TO: Mercedes-Benz Dealer Principals, General Managers, Sales	FROM: Gregory Gunther, Department Manager, Vehicle
Managers, Service Managers, Parts Managers	Compliance and Analysis, Engineering Services
RE: Emission Modification Notification – [[2020050022]]	
MY 10-12 GL350 BlueTec 4MATIC Update – Emission	DATE: January 13, 2022
Modification Category (EMC) #5

Campaign No. 2020050022, January 2022

SUBJECT:Model GL-Class diesel vehicles (X164 platform)Model Year 2010-2012Modification to the emission control system

Figure 1

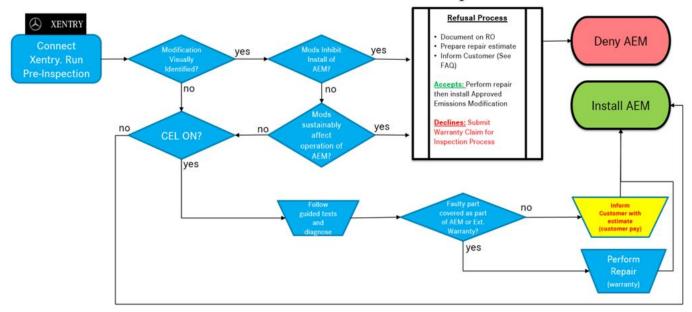
i Note: goal of the pre-inspection process is to perform an inspection of the emission system and ensure all components are present and functioning correctly (Check engine light "CEL" ON/OFF). The pre-inspection consists of the following procedures as displayed in the below flowchart:

- 1. Visual inspection of the emissions system to check for non-compliant alterations to the emission system that impedes the installation of the AEM or substantially effects the operation of the AEM after installation. This consists of a brief visual inspection and does not require a technician to confirm if components are operating correctly. (Example: missing emission system components not replaced as part of the AEM)
 - a. If an alteration has been found during the visual inspection that meet the criteria mentioned in point 1, please advise the customer these alterations must be reversed at their expense before to proceed with the AEM. Please follow the below process to submit a warranty claim for the time associated to diagnosis and provide an estimate to the customer.

- 2. Initial Short Test to check for CEL ON/OFF: Pre-existing issues (CEL ON) may be addressed at the time of AEM install if the components diagnosed are part of the AEM or extended warranty. For all other components, please provide a customer a repair estimate and document if the customer approves/declines the additional repair(s). It is essential the AEM is installed regardless if the customer approved/declines additional repairs to address a pre-existing issue. A list of applicable extended warranty parts is available in Xentry for the technician to refer to.

Figure 5

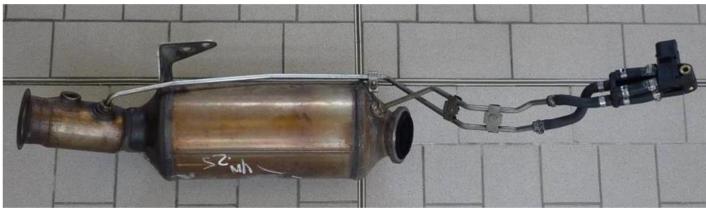
Li Catalytic converter diesel particulate filter unit with connected differential pressure lines **(Figure 5)**. Rebuild the differential pressure lines only in the removed state.

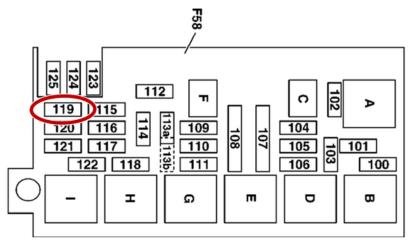
6. <u>Replace the DEF injection nozzle (A 164 490 26 00 80).</u>
